**EVALUATION OF HALTON REGION
LANDFILL TECHNICAL STUDIES
Site F - Burlington**

HYDROGEOLOGIC REPORT

- **Part A - Definition of Hydrogeologic Suitability
for Landfilling**
- **Part B - Critique of Trow Technical Studies**
- **Part C - Interpretation of Site F Hydrogeology and
Suitability for Landfilling**

February 8, 1988

figure B.2.1

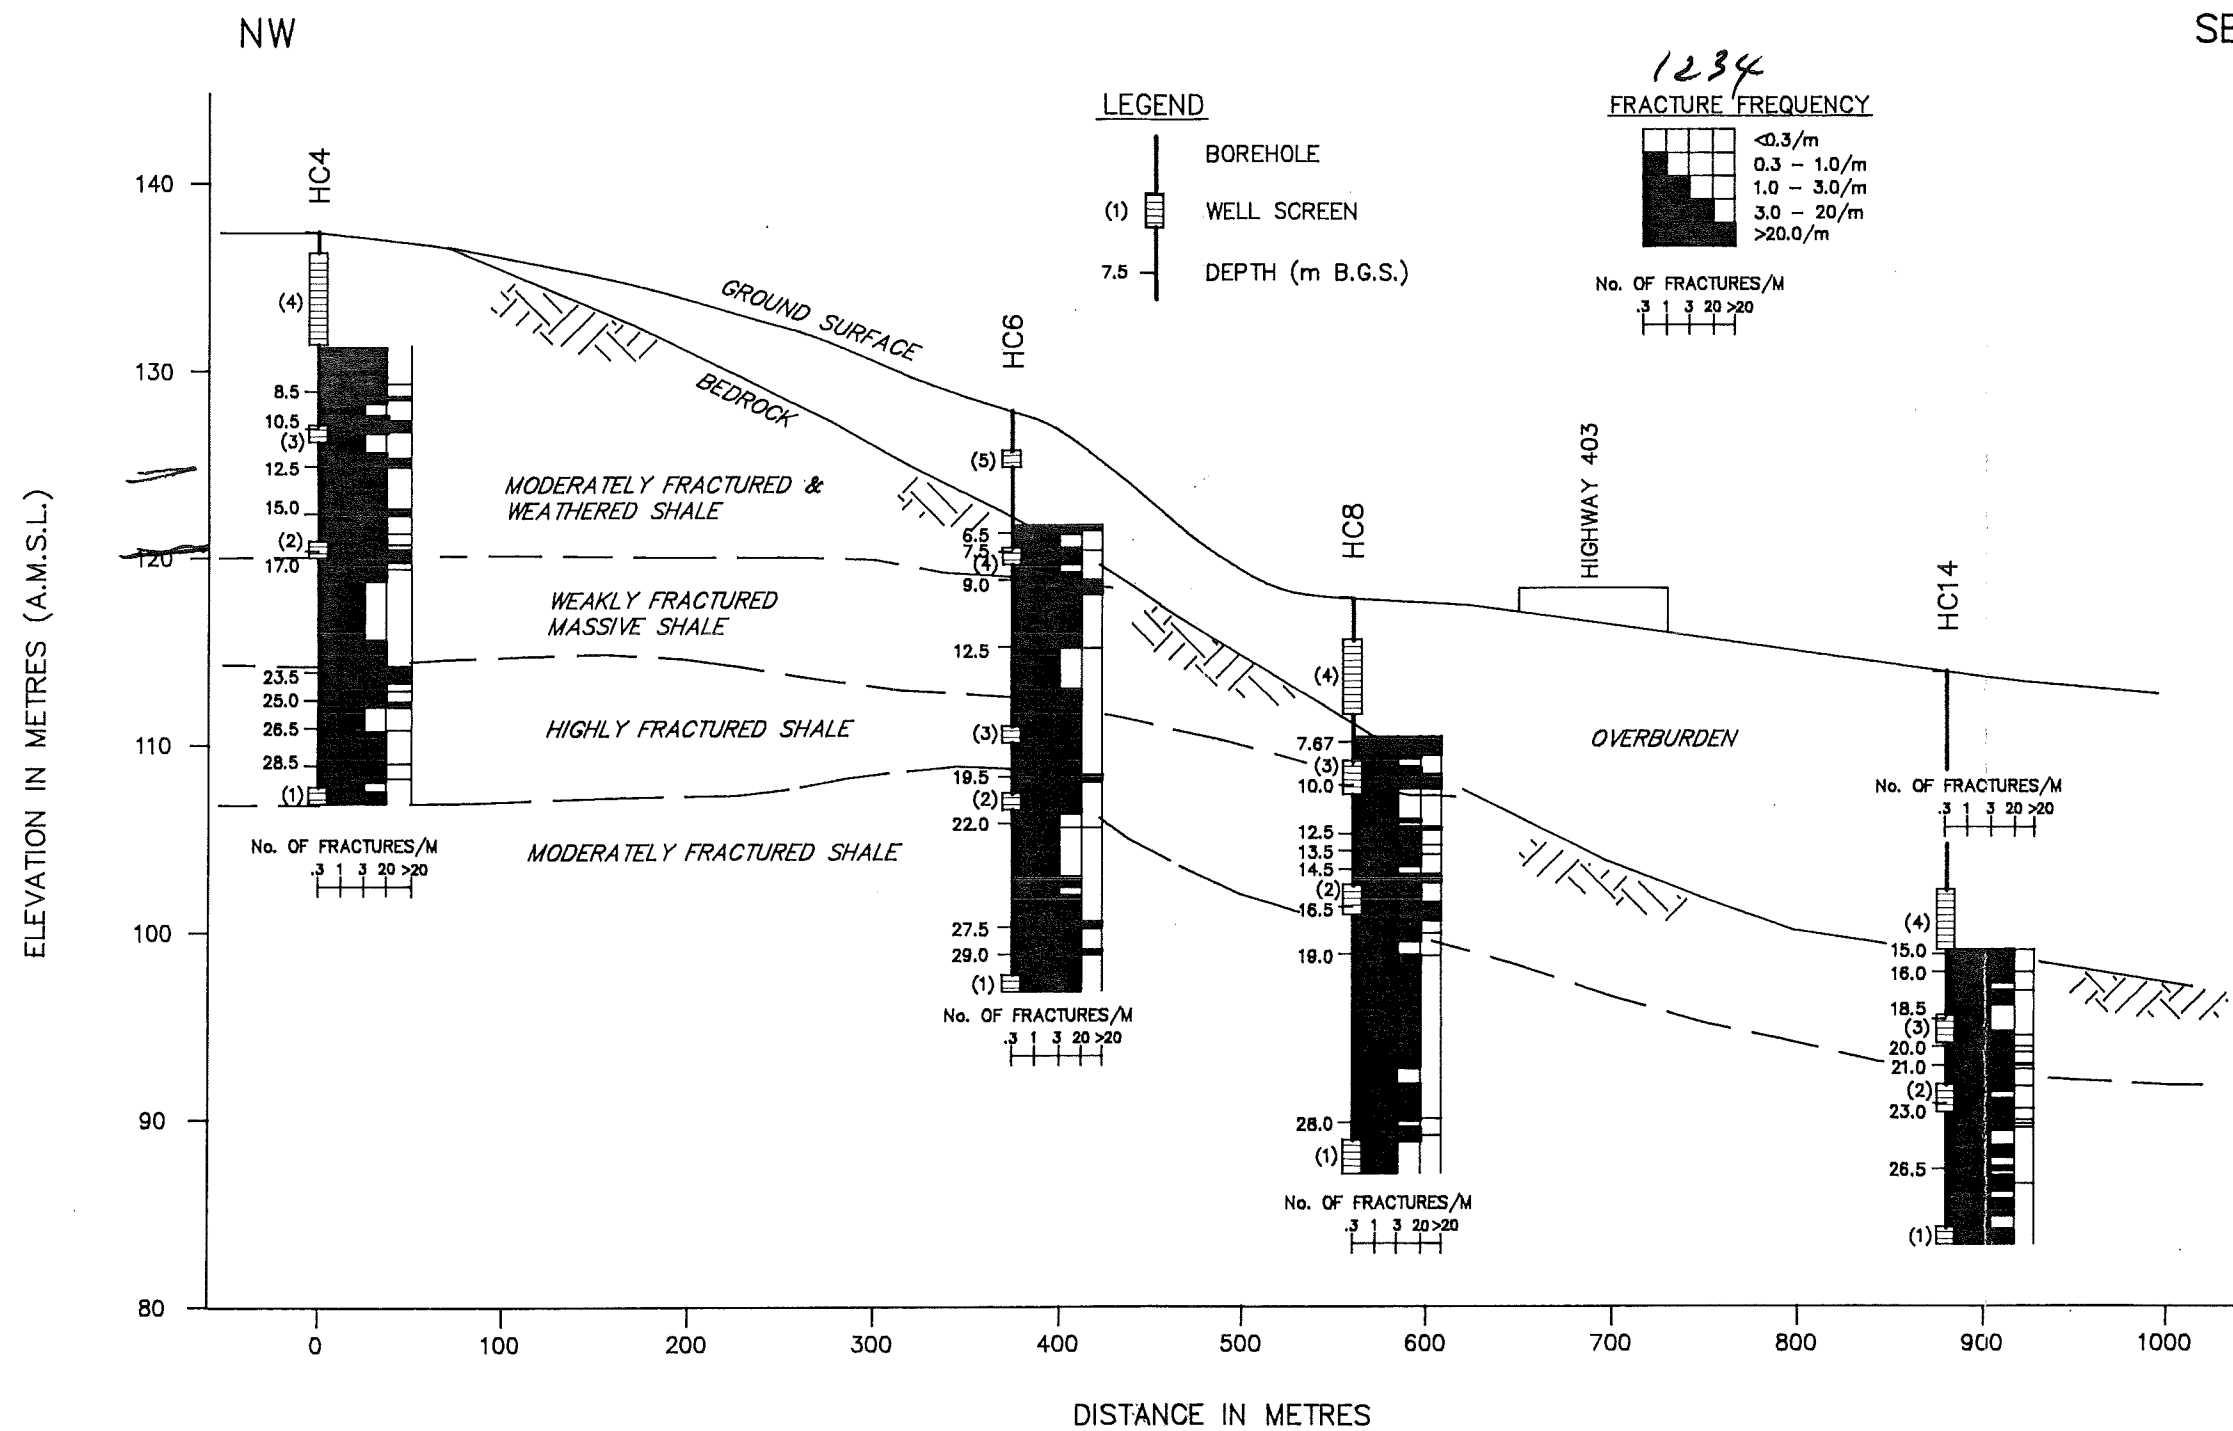
CRA does not agree with the delineation of the fracture zones presented by Trow as interpreted from a detailed study of the core logs. This delineation as presented by Trow (Figure 2, p. 35; Exhibit H-40) is reproduced here as Figure B.2.1 (p. 21).

figure B.3.2
 EXHIBIT H-220
 HYDROSTRATIGRAPHIC FRAMEWORK WORKING DRAWING
 Site 'F'—Hydrogeology — City of Burlington

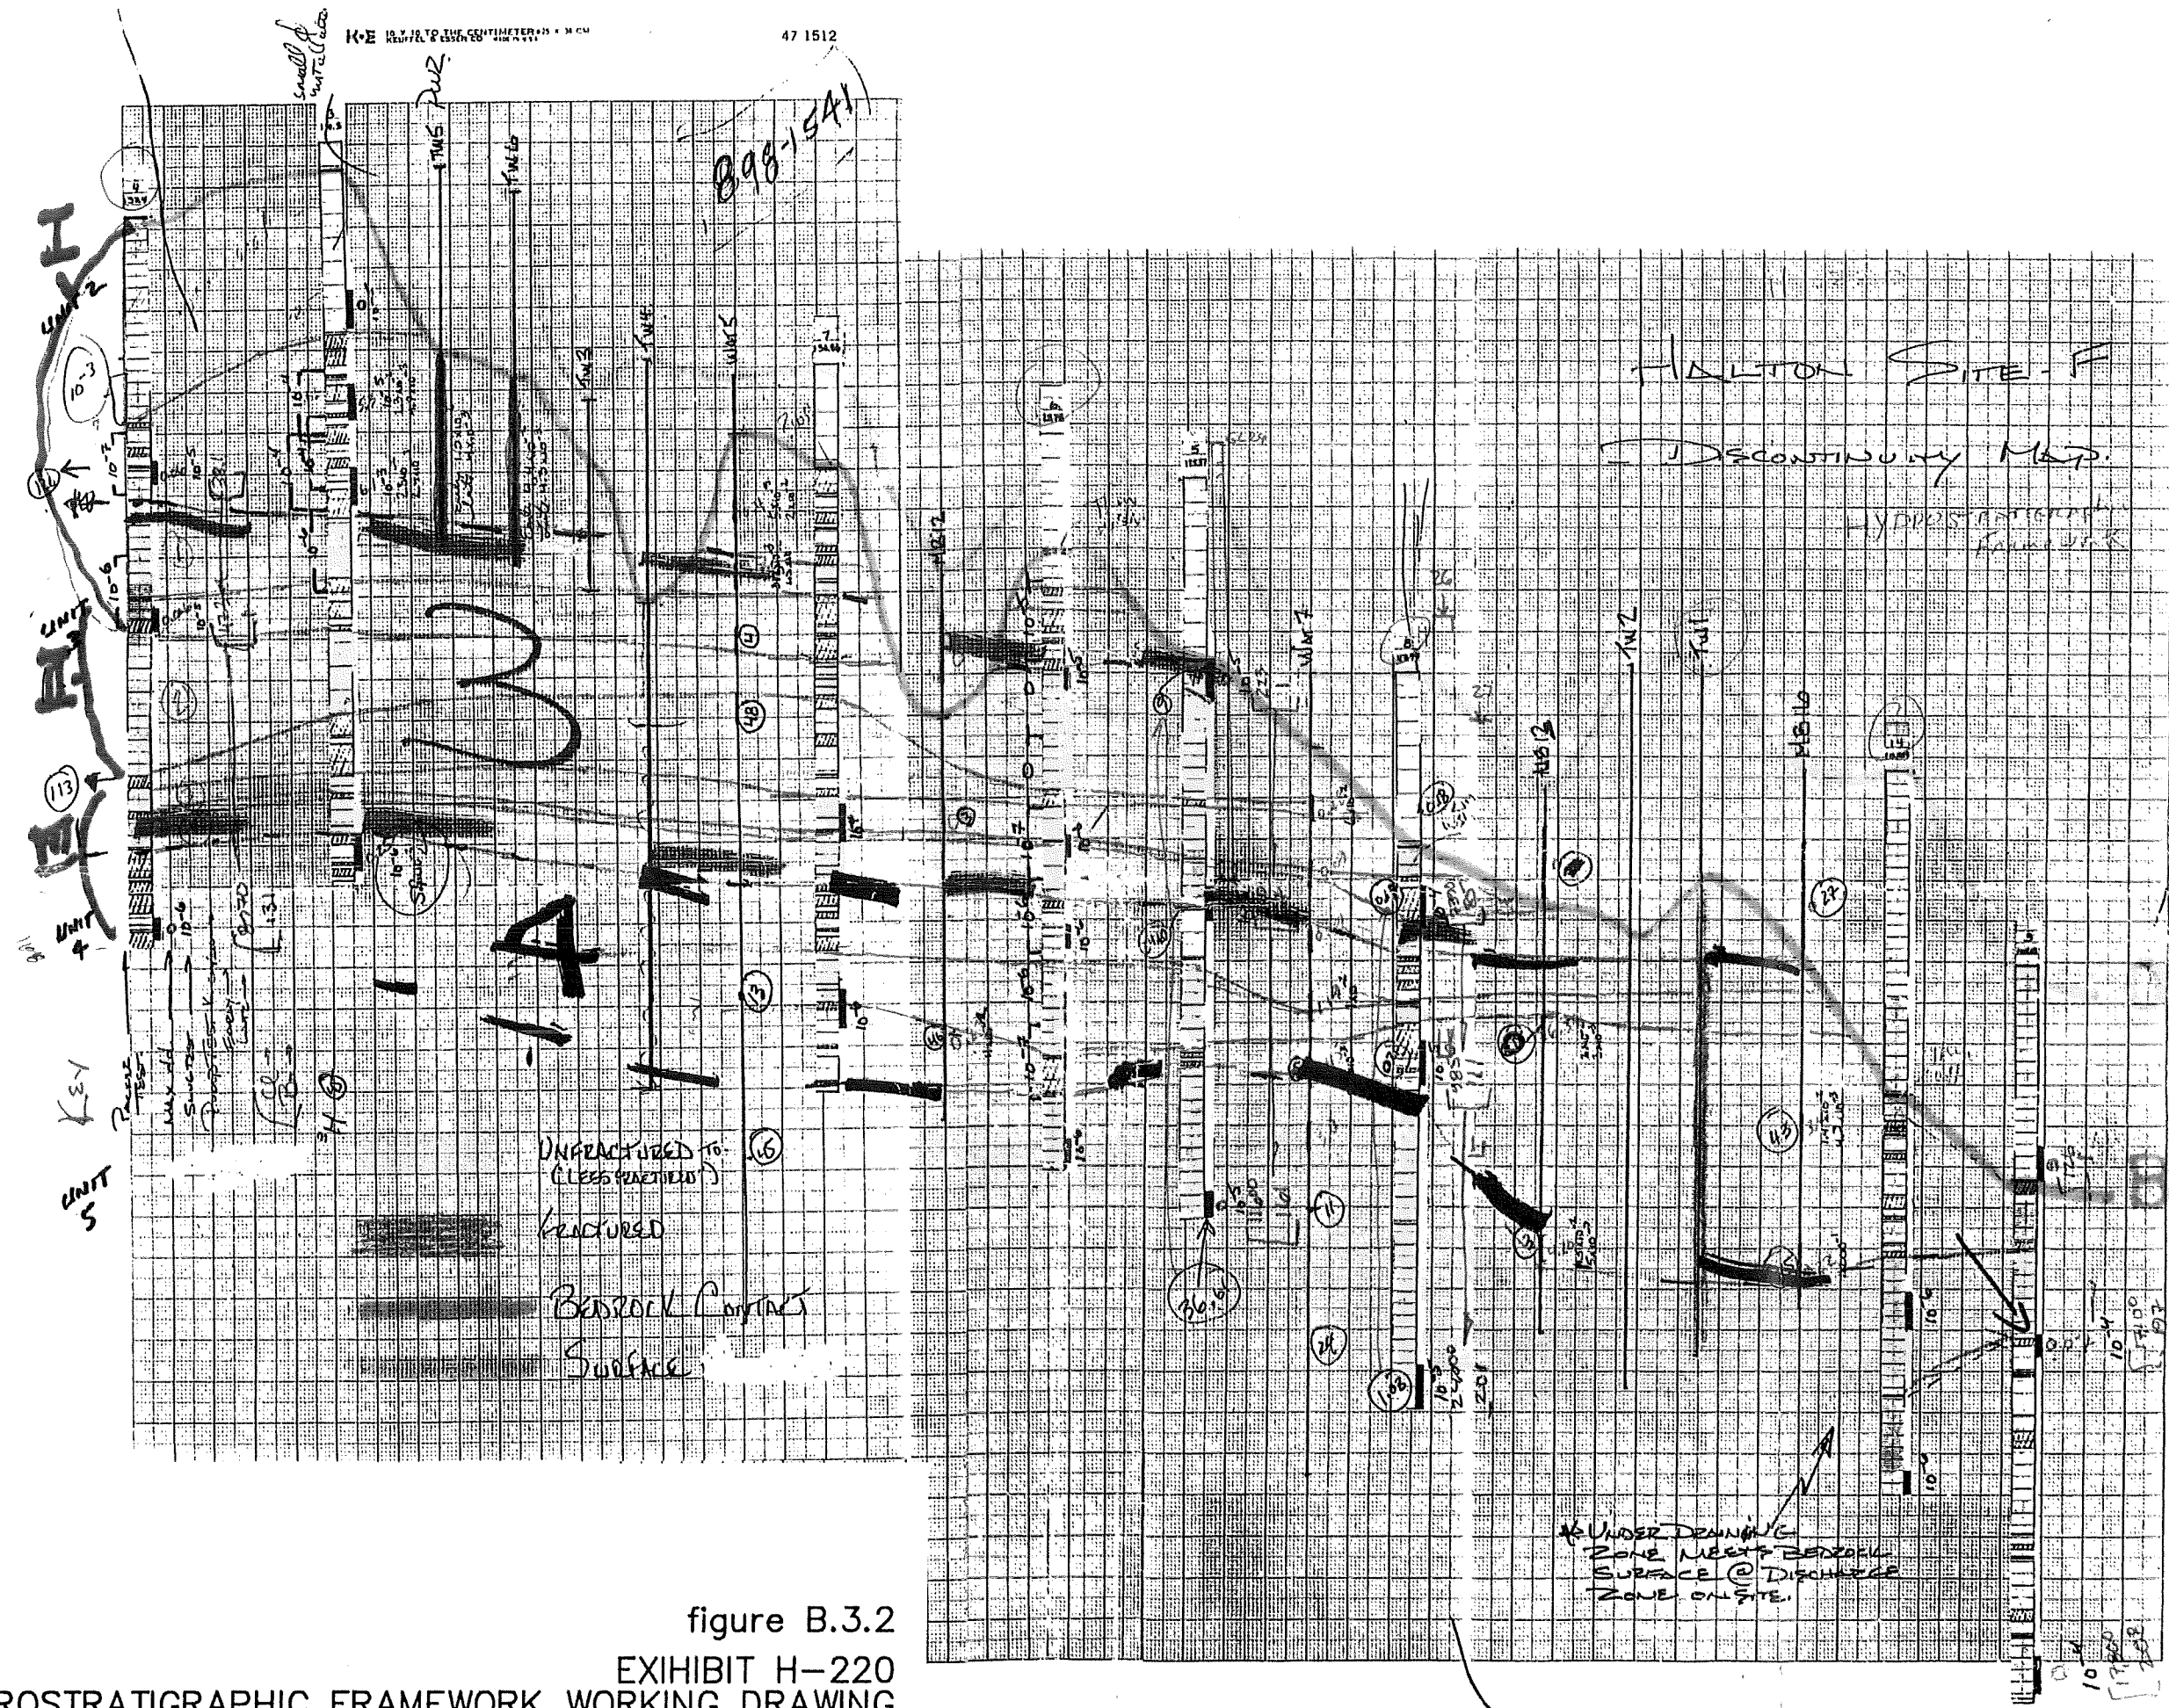
From inspection of Figure B.3.2 (Exhibit H-220), a thickness for the 'weakly fractured shale' (Unit 3) of 20 m is not supported by the data provided. Similarly, the wedge shape for Unit 4 is not supported by the field data.

Accordingly, it is CRA's opinion that the working drawing (Exhibit H-220) does not support the hydrostratigraphy summarized on Figure B.3.1 (p. 27).

figure B.3.3
HYDROSTRATIGRAPHY
Site 'F' - Hydrogeology - City of Burlington

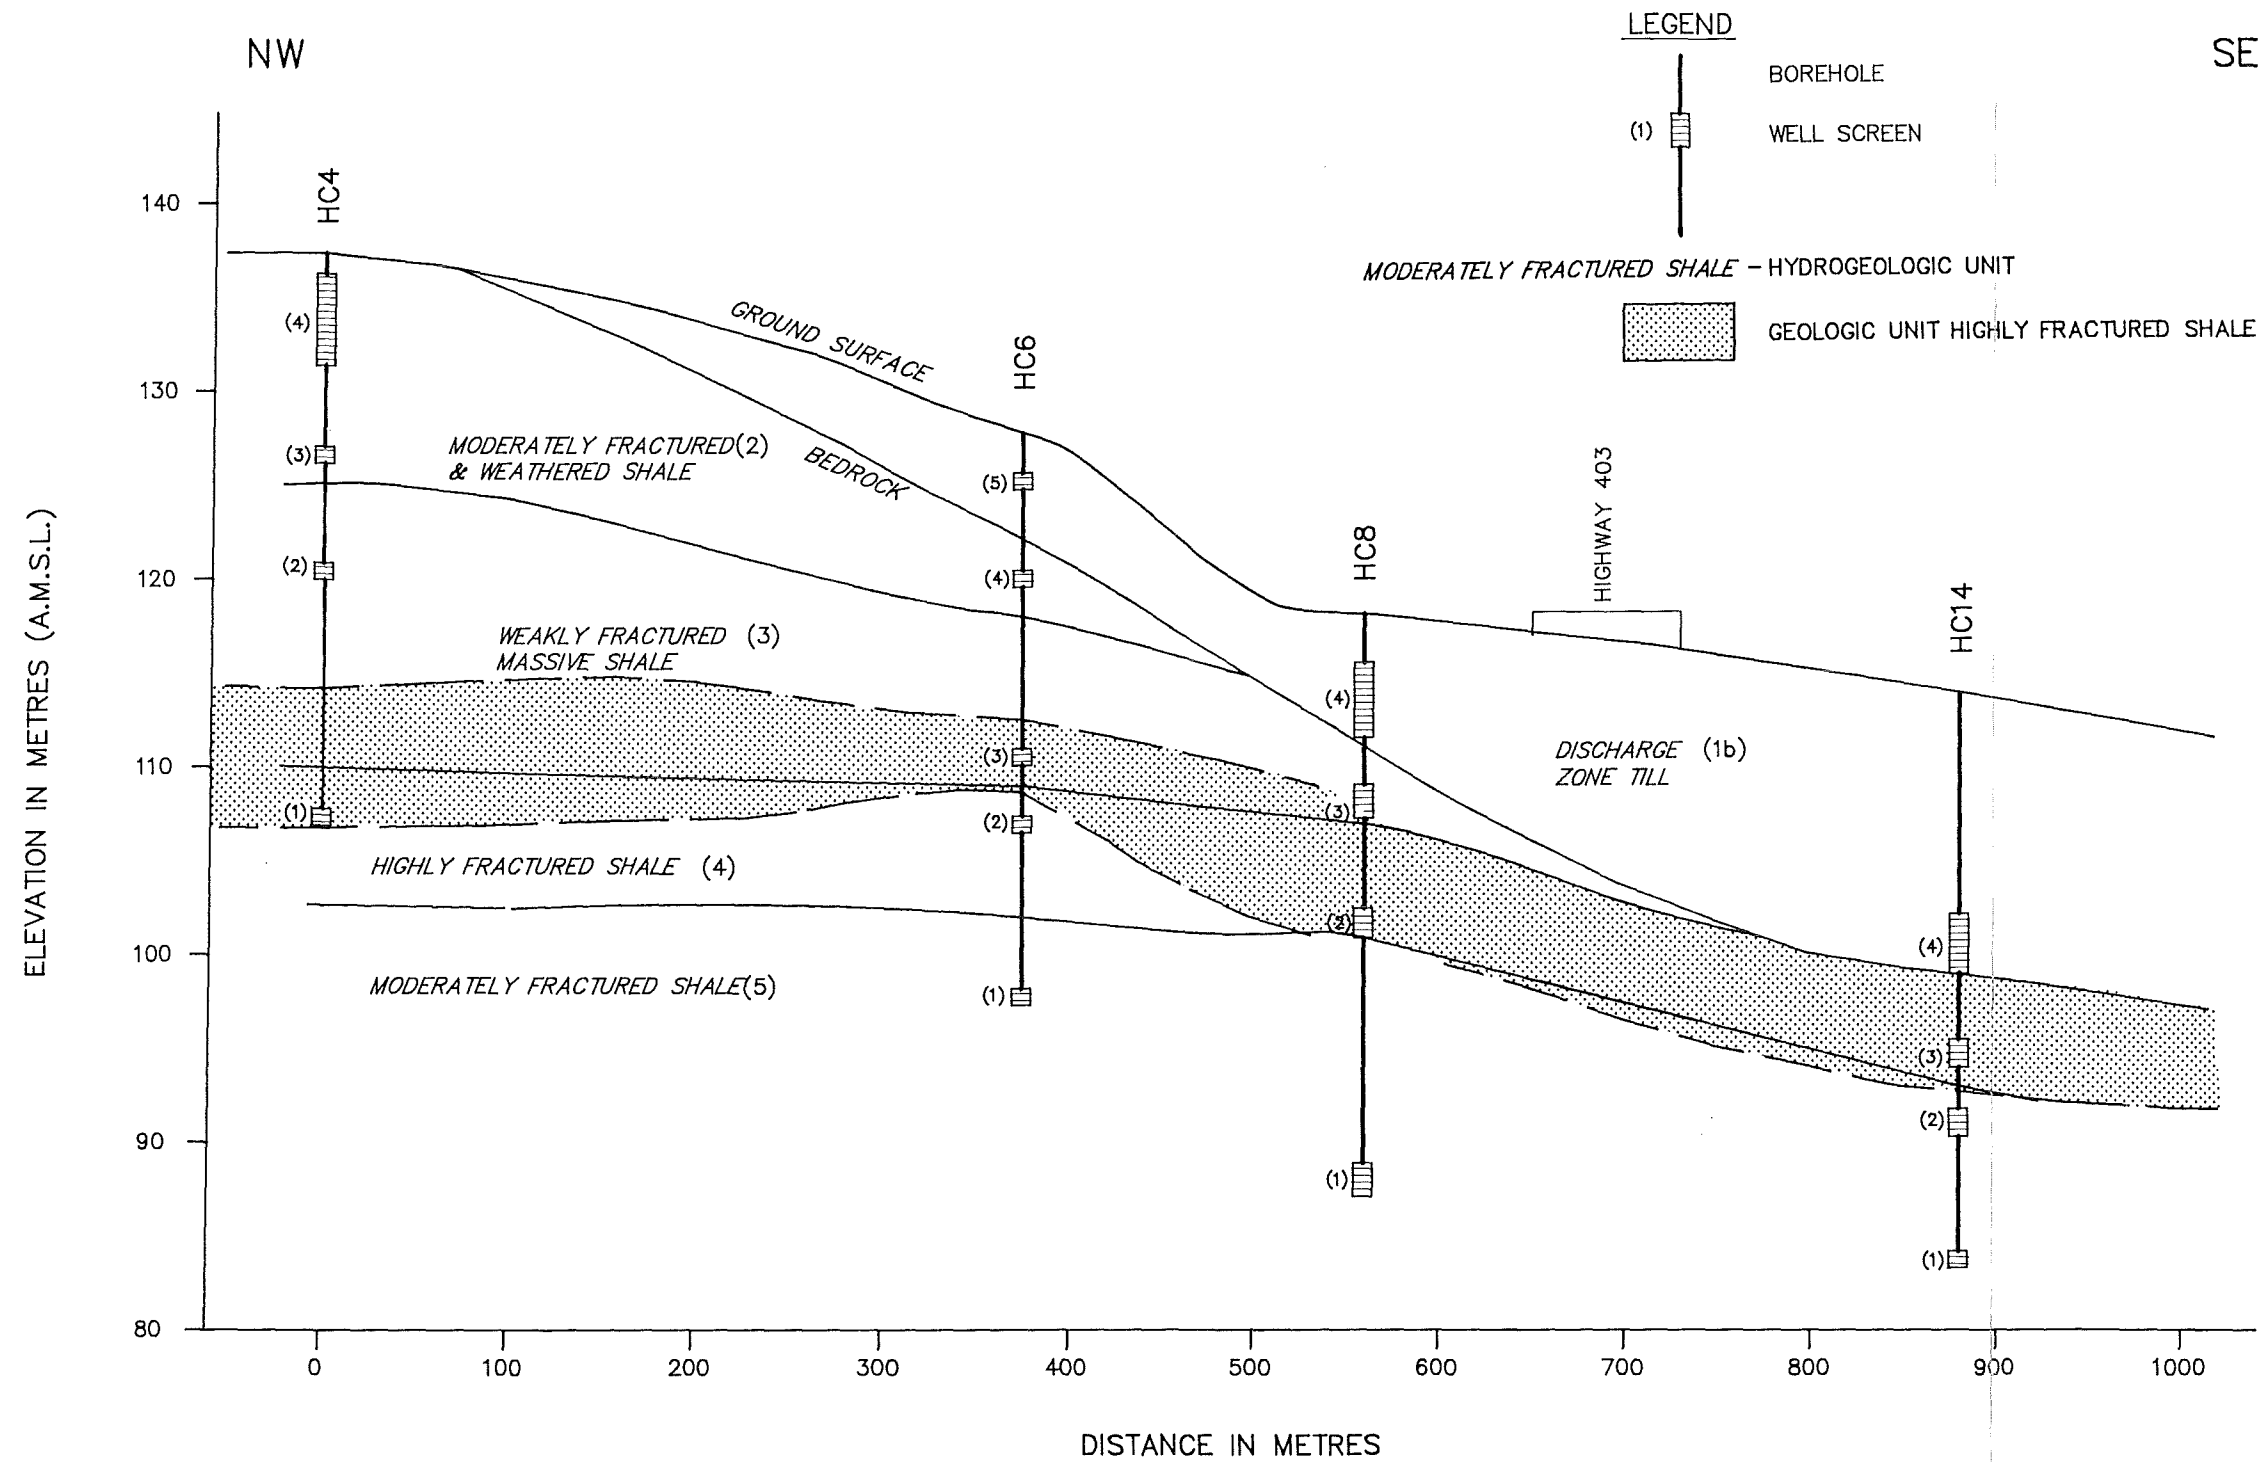
This figure shows that the 'highly fractured shale' (geologic unit) at HC6 lies within the 'weakly fractured massive shale' (hydrogeologic unit 3). This confirms Mr. Beechinor's conclusion, that it is not possible to define the position of the hydrogeologic units based solely on inspection of the fracture frequency or discontinuities (Vol. 37, p. 8131).
